Palmdale Hybrid Power PROJECT

Supplemental Responses to CEC Data Requests Set 1

Docket 08-AFC-9

**PALMDALE HYBRID POWER PROJECT (08-AFC-09)
CEC STAFF SET 1 DATA REQUESTS 28, 31 & 39 – 49**

GENERAL ARRANGMENT POWER BLOCK

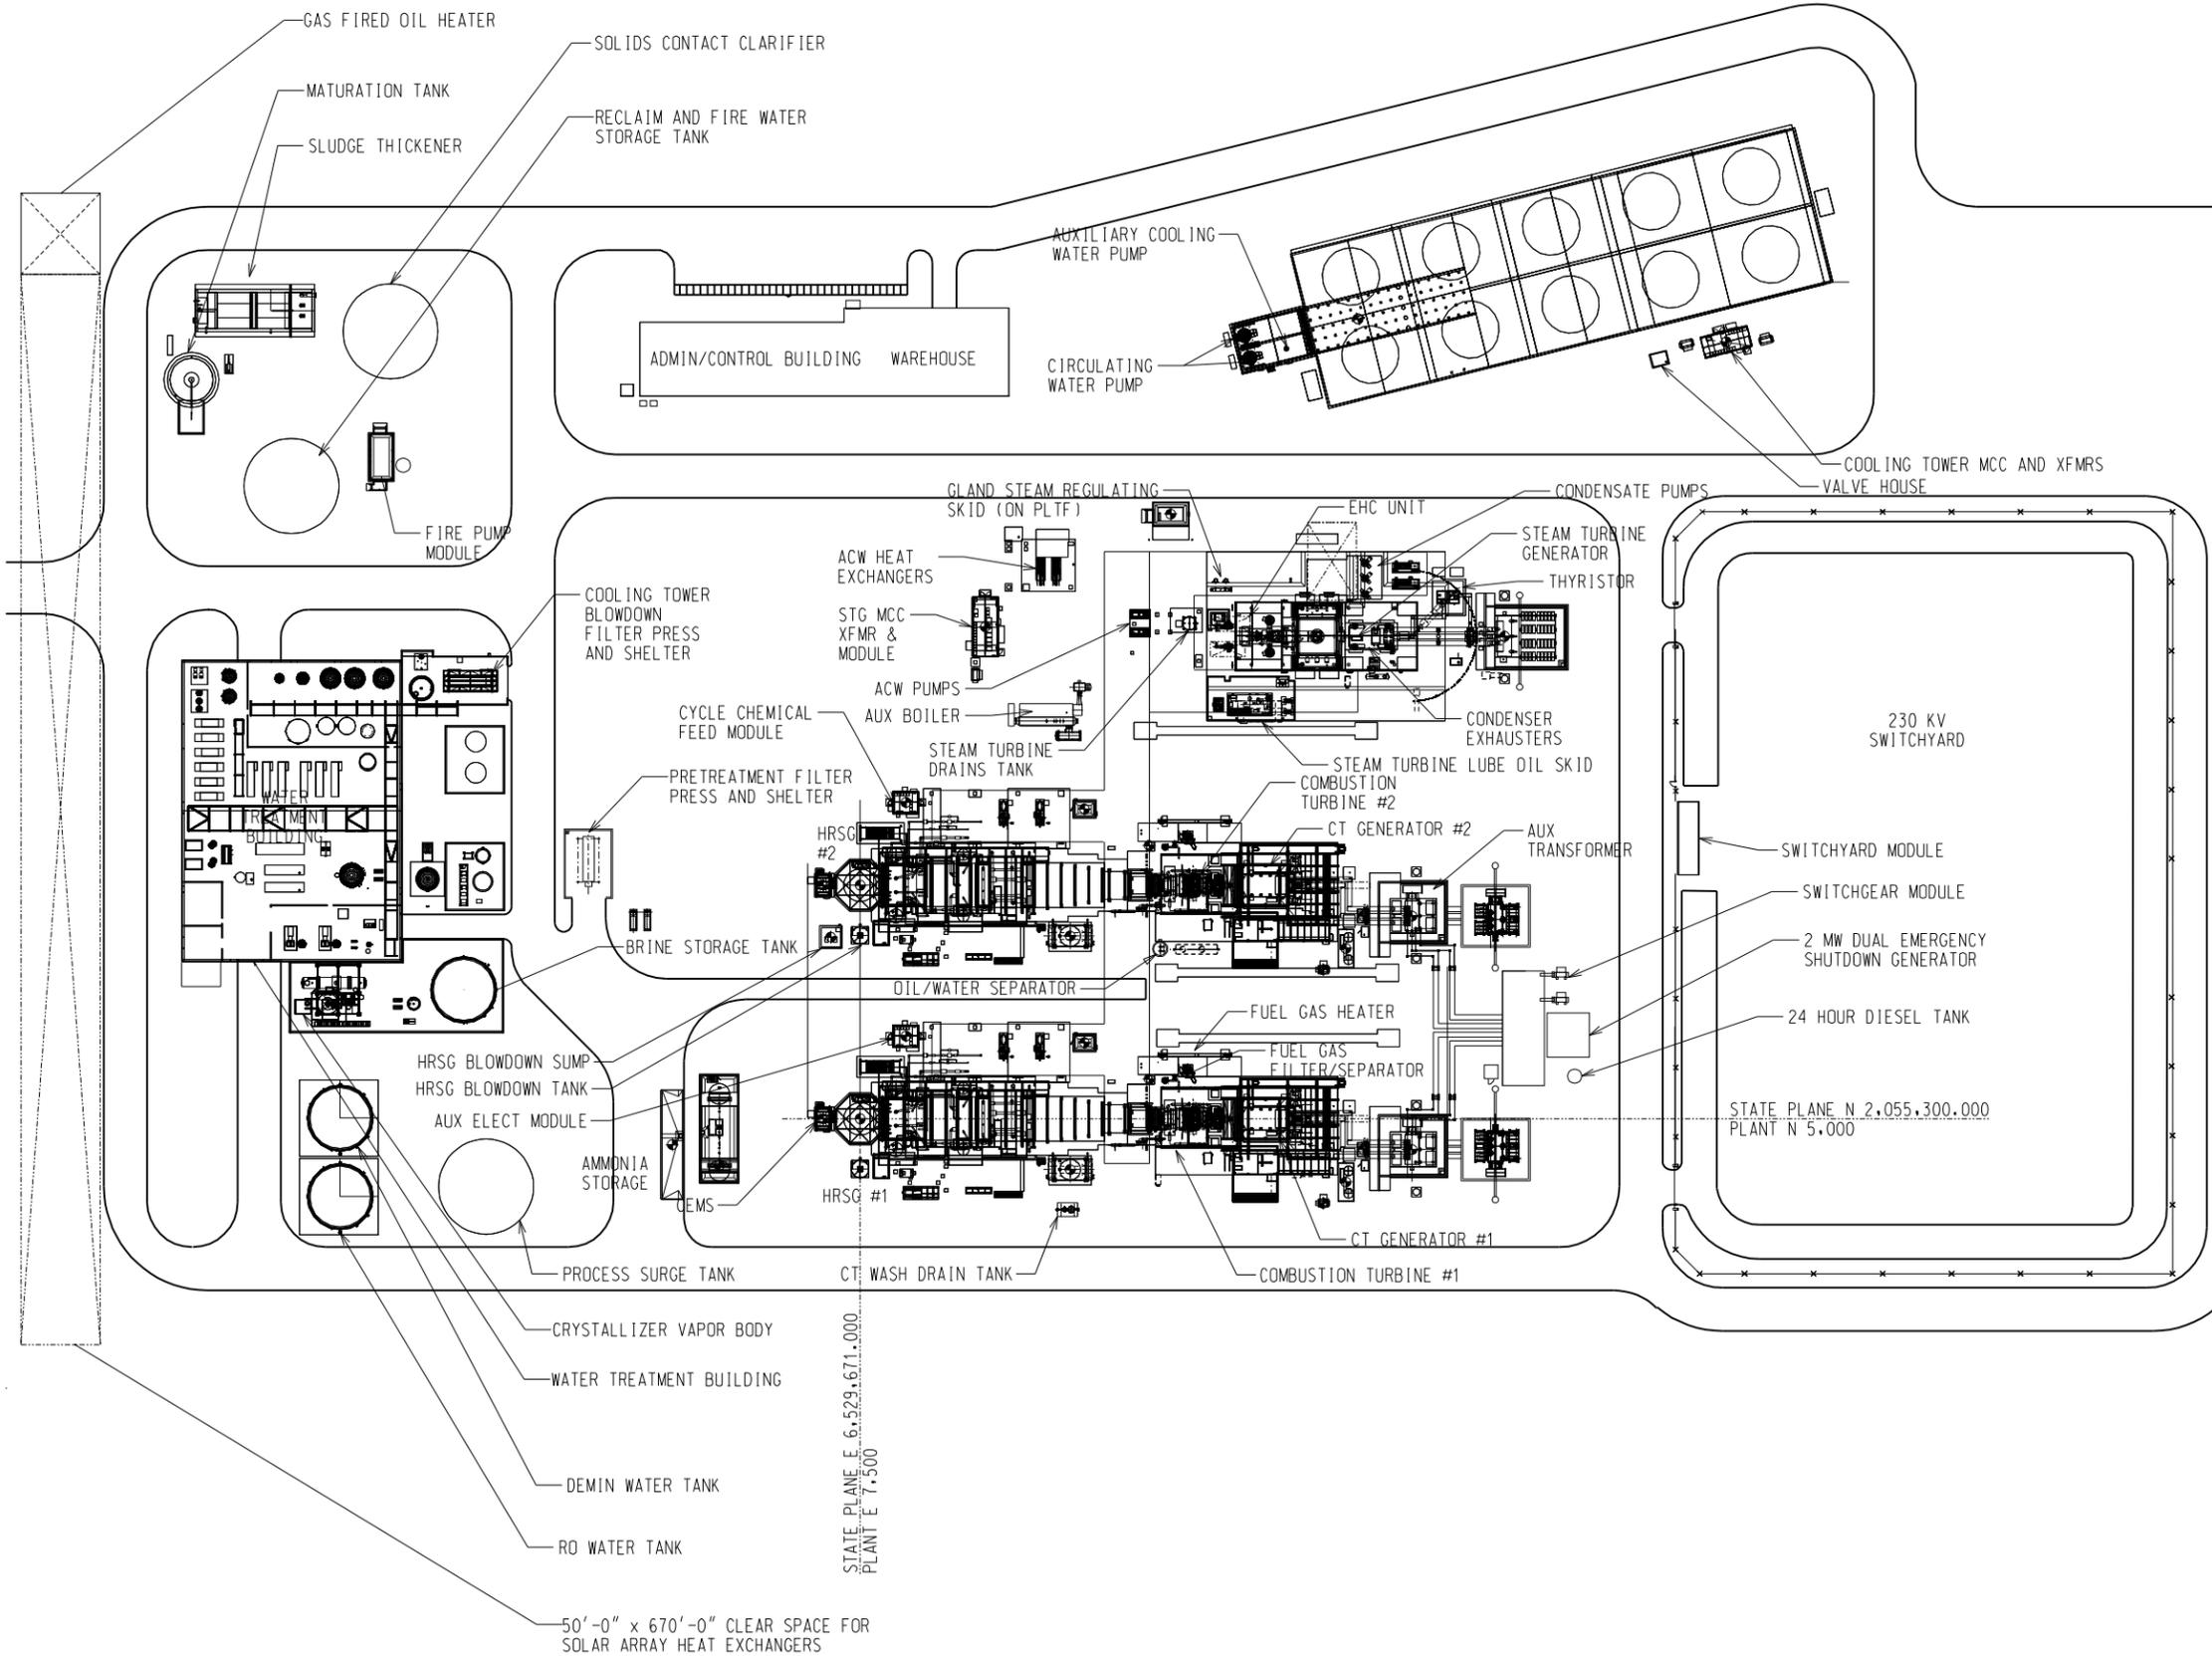
AFC Figure 2-5 provided a General Arrangement of the Power Block, and a revised figure that reflects the changes discussed above is provided at the end of this section.

- Changes in the power block plot plan and sources include slight relocation of the combustion turbines, increase in the size of the Auxiliary Boiler from 100 MMBtu/hr to 110 MMBtu/hr including increasing the stack height (from 30 feet to 60 feet), decrease in the stack heights (from 30 feet to 16 feet) of the emergency diesel generator and fire water pump engine, and relocation of the ammonia storage tank.

Due to the new boiler and further engineering on the power block, a few other minor changes were made. Design refinements to the auxiliary boiler resulted in an increase in the planned stack height from 30 feet to 60 feet. The distance between the two combustion turbine stacks was increased to 135 feet, allowing for more room for duct bank placement in between the stacks. The emergency generator and fire water pump engine was previously assumed to be located inside the larger buildings in the power block. These buildings had a nominal height of 24 feet and the projected stacks were proposed at six feet above this height. Subsequent design refinements now have these emergency engines with 16 ft stack heights. Other slight changes, such as moving the ammonia storage tank, were made as result of the combustion turbine stack relocation.

Palmdale Hybrid Power Project Map #090224

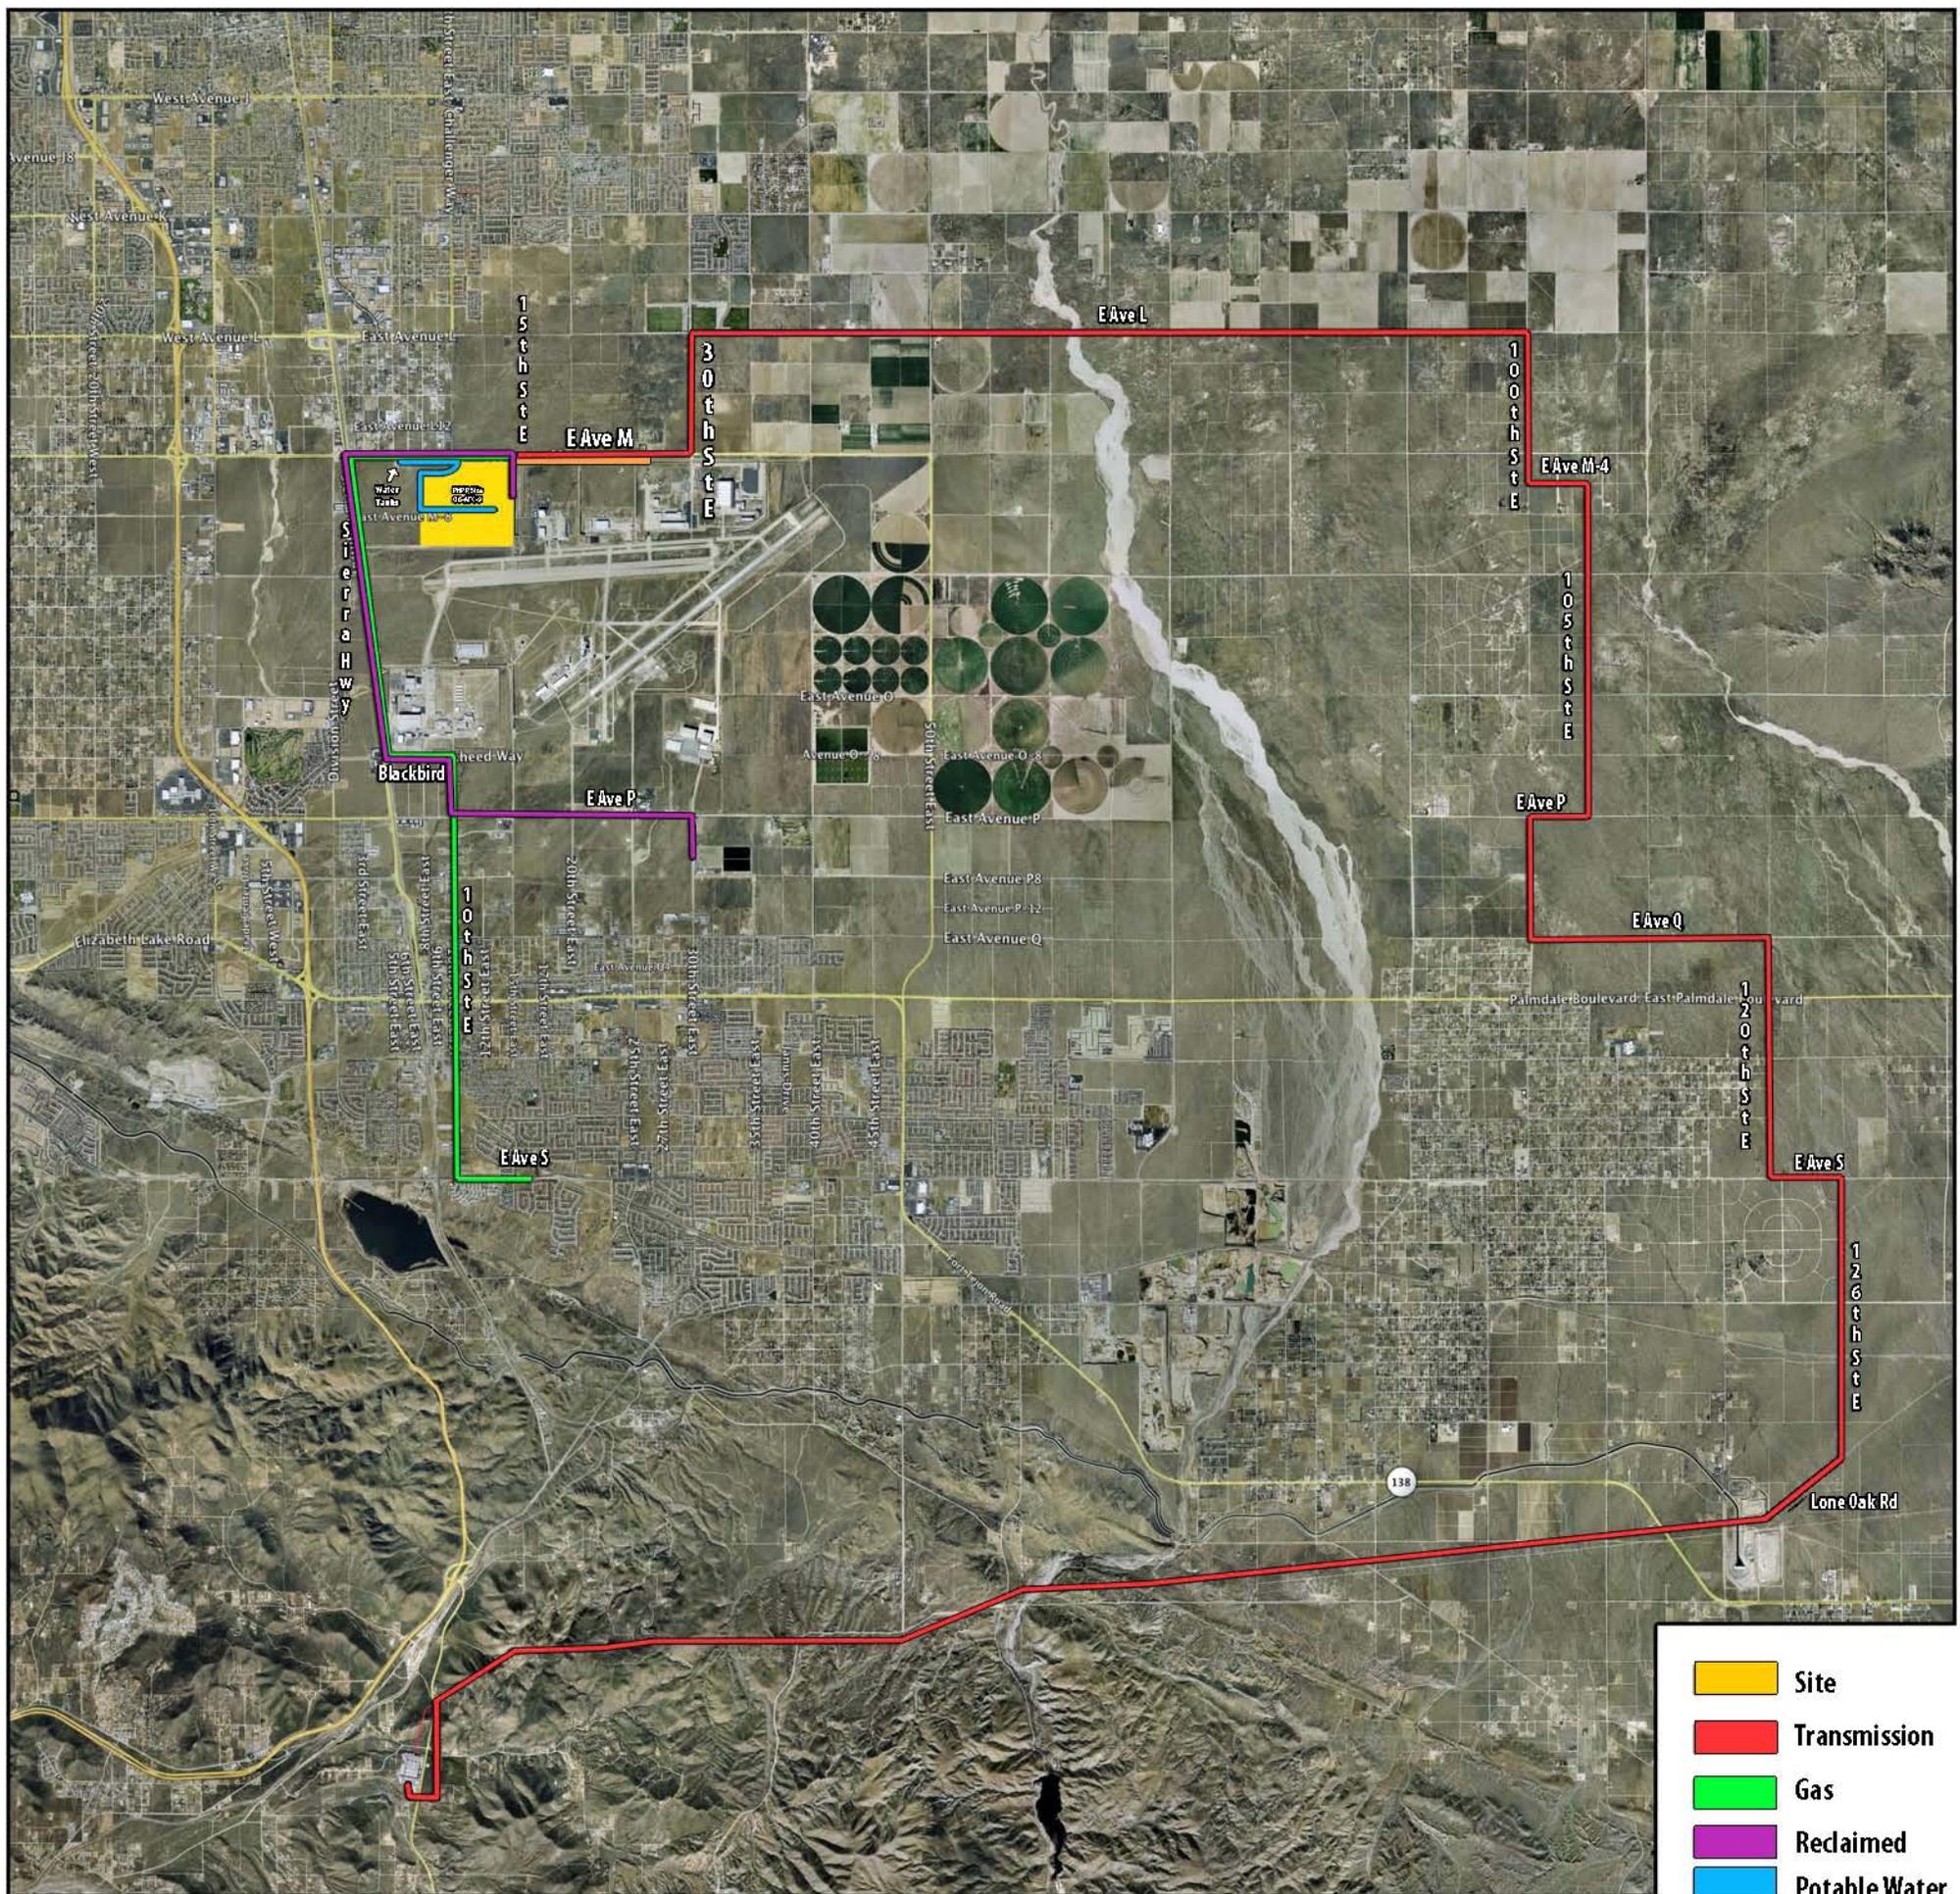
The new proposed routes for the sanitary wastewater and the potable water pipelines are shown on a figure showing all of the linear routes. This new figure, PD-1, is provided at the end of this section.

The changes to Segment 2 of the transmission line are shown on the figure showing all of the linear facilities (same figure as above for the potable and wastewater pipelines) provided at the end of this section, as well as in the revised Google Earth fly-over which is included in the CD as part of this submittal.

The potable water line alignment has also changed from that portrayed in the original AFC submittal. The potable water pipeline originates on E Ave. M near the water tanks between 5th and 6th St. E. It used to proceed along E Ave. M, turn south along 15th St. E and enter the power block from the east. The new proposed alignment will instead proceed along E Ave. M, but turn south sooner at the new site entrance on 10th St. E, follow the new access road entering the power block from the west. This new alignment will better support potential City plans for development of the western portion of the site. The change to the alignment is wholly within the PHPP power plant site which has already been surveyed. The route proposed to travel east along E Ave M between 5th St. E and 10th St. E has also been surveyed since this is part of the original potable water alignment. Hence, no additional impacts have been identified due to this change.
